Metro Outer Development Assessment Panel Agenda

Meeting Date and Time: Tuesday, 13 October 2026; 1.00pm
Meeting Number: MODAP/164
Meeting Venue: 140 William Street, Perth

Part B – Item 4.1 - LOT 201 (NO.231) MORRISON ROAD, MIDVALE

RESPONSIBLE AUTHORITY REPORT – FORM 2	
DAP File No:	DAP/22/02304
LG Reference:	DA-495/2022/B
Approved Development	Mixed commercial development comprising of a Shop, Fast Food Outlet, Veterinary Centre and Child Care Premises
Proposed Amendments:	• Replacement of approved 600m² childcare building with proposed 417m² Motor Vehicle repair building with reduced setback and removal of boundary landscaping. • Proposed use of approved 537m² Retail Building as Restaurant and Fast Food outlet and increase to 554m². • Increase of approved Fast Food Outlet from 215m² to 311m². • Modification to site carparking layout
Owner:	Northstead Pty Ltd
Applicant:	Rise Urban
Local Government Area:	City of Swan
Responsible Authority:	City of Swan
Authorising Officer:	Manager - Statutory Planning
Date of Original DAP decision:	24 January 2023
Date(s) of previous amendments:	1 November 2023
Application Acceptance Date:	12 June 2026

PROPOSED SITE PLAN
SCALE: 1:250

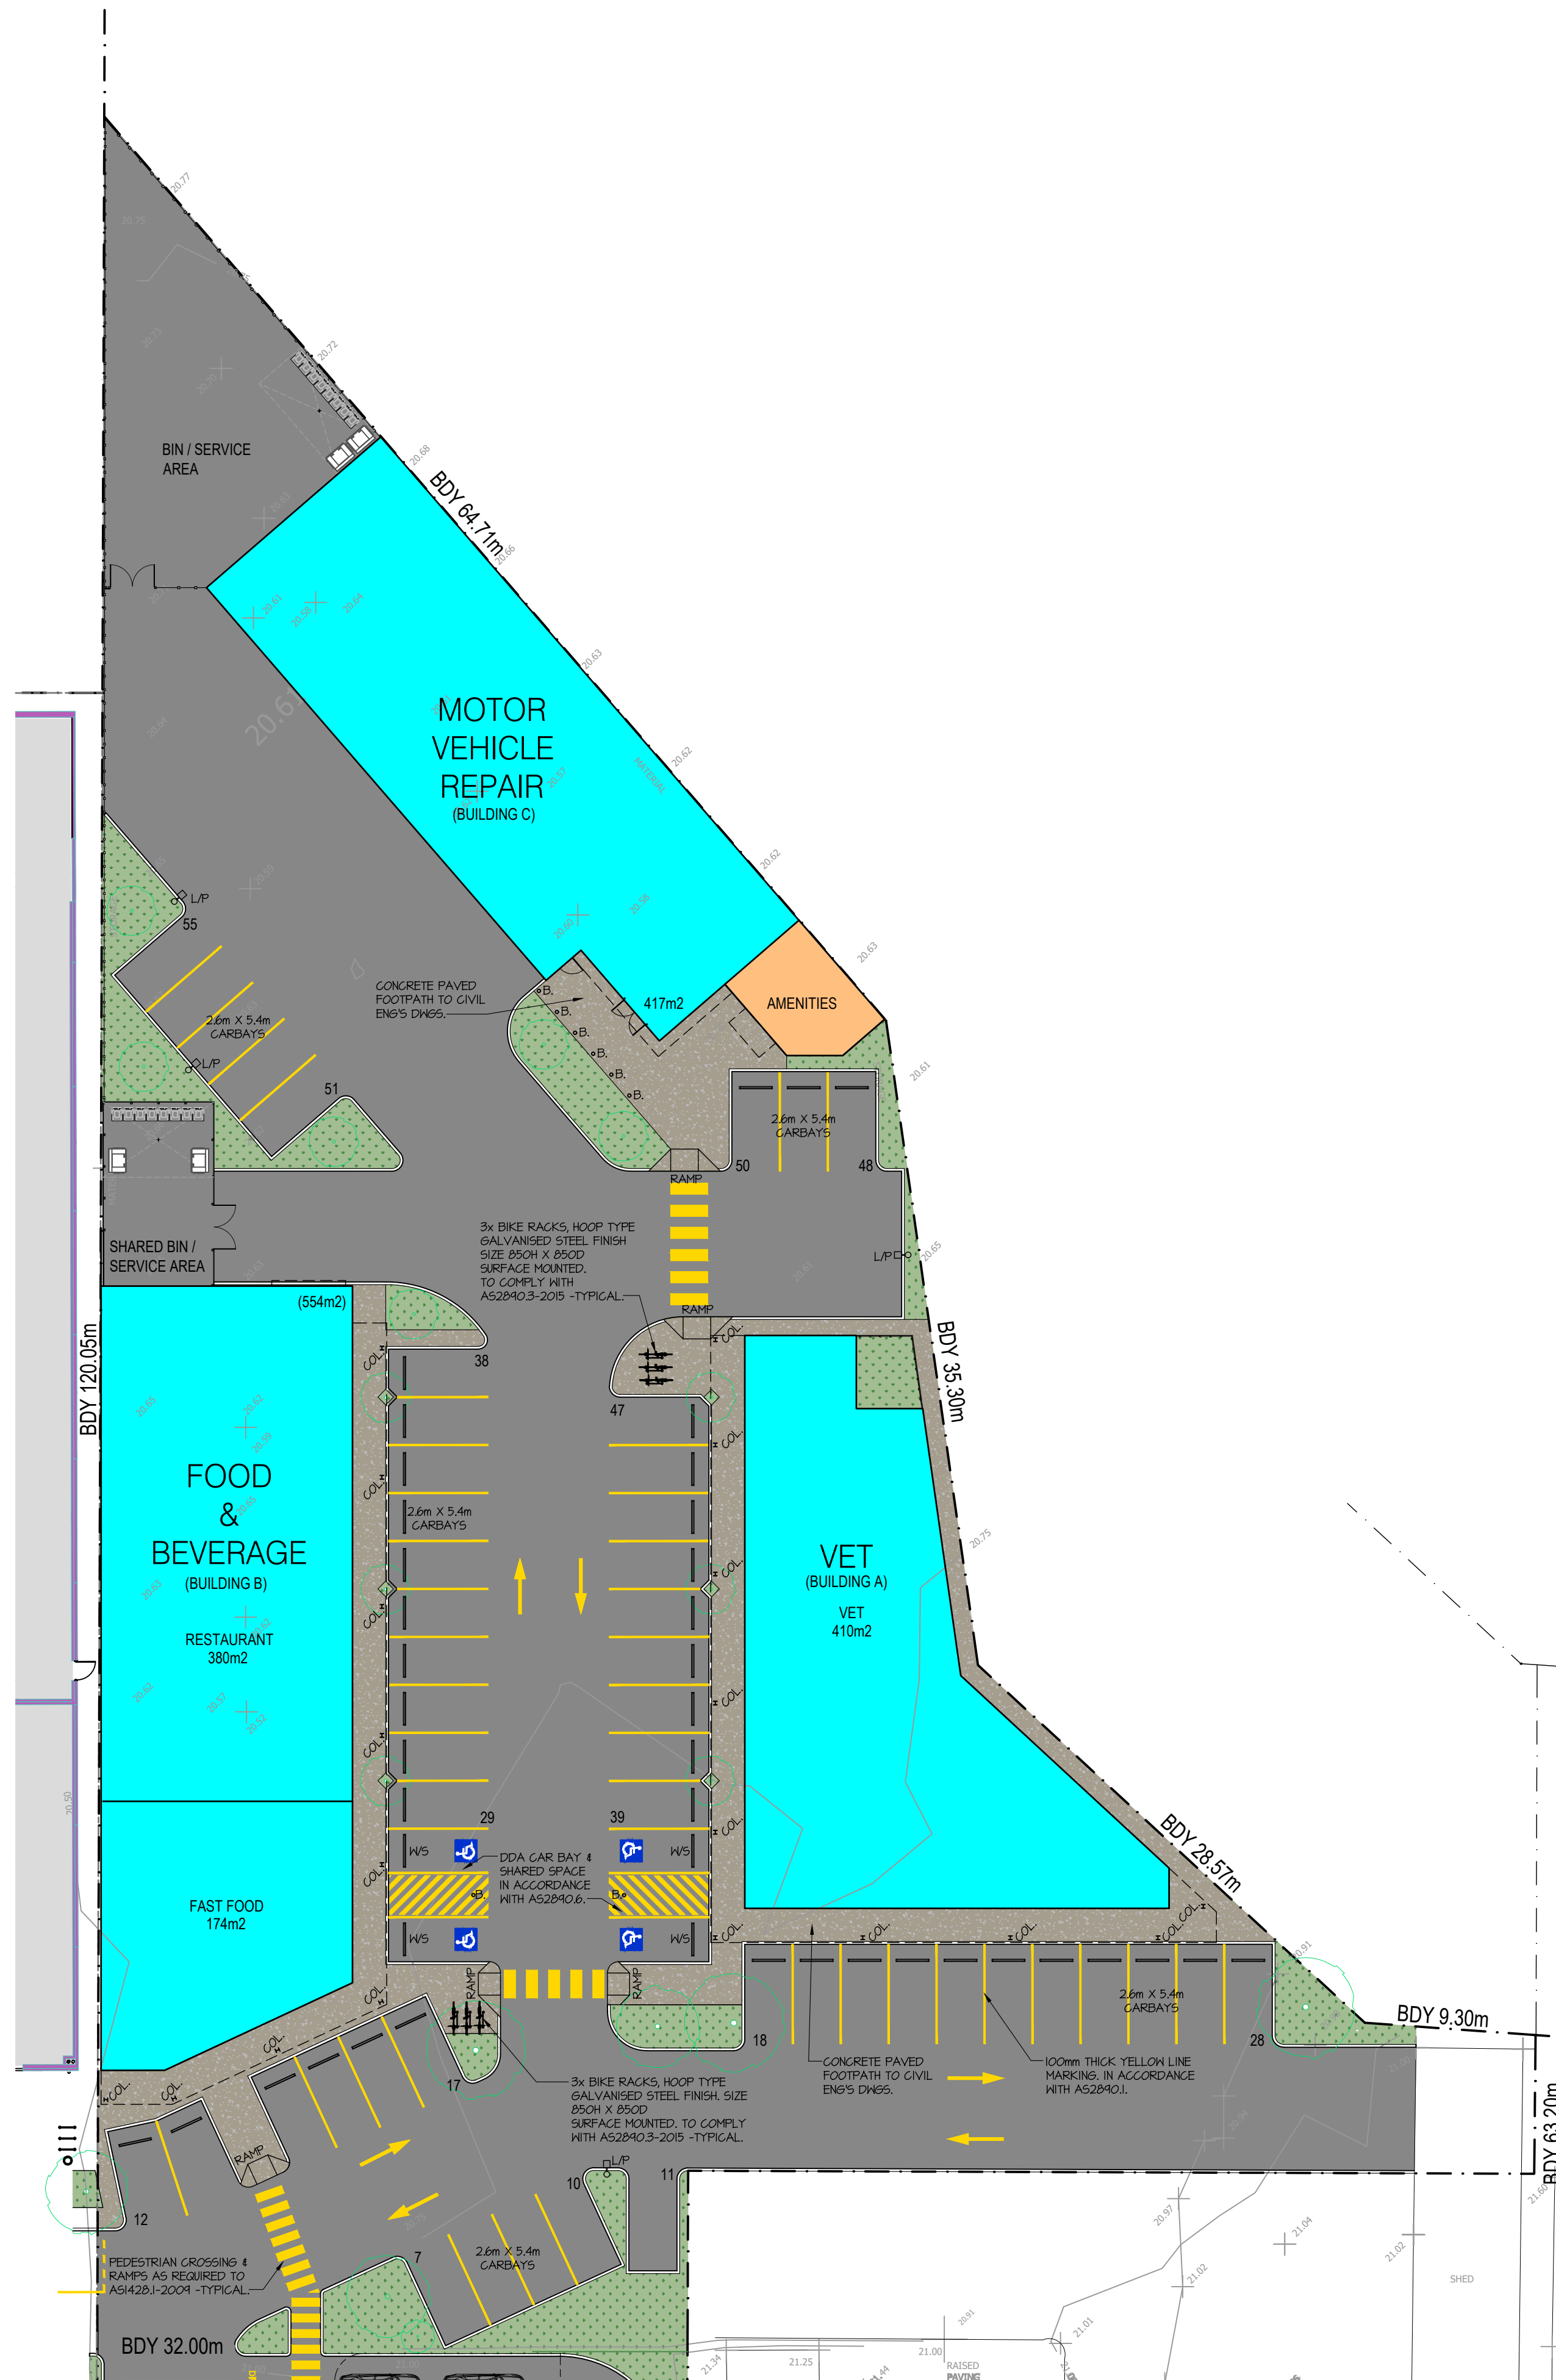
City staff consider that the proposed changes to the current approval substantially change the development approved. The proposal changes two of the four land uses approved for the land, most significantly swapping the approved childcare premises for motor vehicle repair use. This is a materially different type of land use with significantly different permissibility across land use zones under the City's Local Planning Scheme No.17. Further the "shop" use subject of the approval is to be replaced for the most part with a new "restaurant" use.

Of themselves these land use change proposals are considered a significant change to the development approved but the extent of change is compounded by the proposed new building for the 'motor vehicle repair' use. This has an entirely different disposition within the site to the approved 'child care premises' building. That building incorporated setbacks from the eastern side boundary of the lot and the adjoining reserve and a landscaping treatment along that space. The proposed 'motor vehicle repair' building entails a 41 metre long and 7-metre-high parapet wall to this boundary, with no landscaping treatment at all.

Modifications to the floorspace of the approved retail building to accommodate its proposed alternative use for "restaurant" and "fast food outlet" tenancies and an increase in size of the approved "fast food outlet" building from 215m² to 311m² in conjunction with modification to the car parking areas further compound the differences from the development approved.

Initial site plan – June 2022

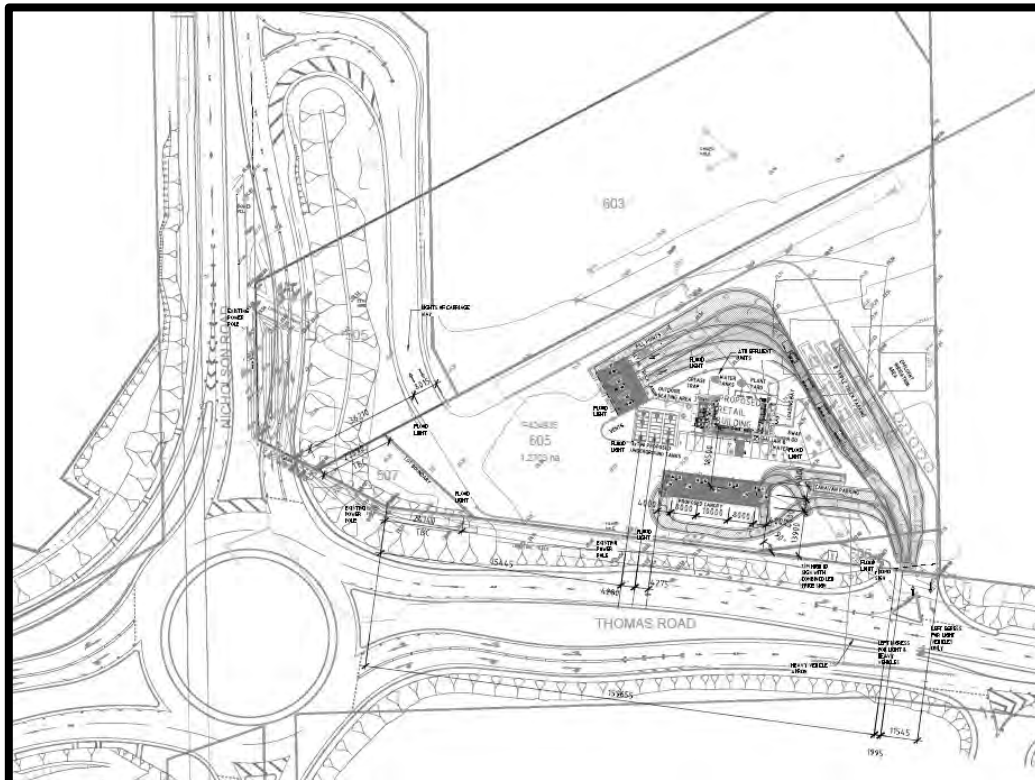
Since that time, the roundabout has been constructed at Thomas Road and Nicholson Road requiring the site plan to be updated showing the ultimate access arrangements. The site plans are shown following:-
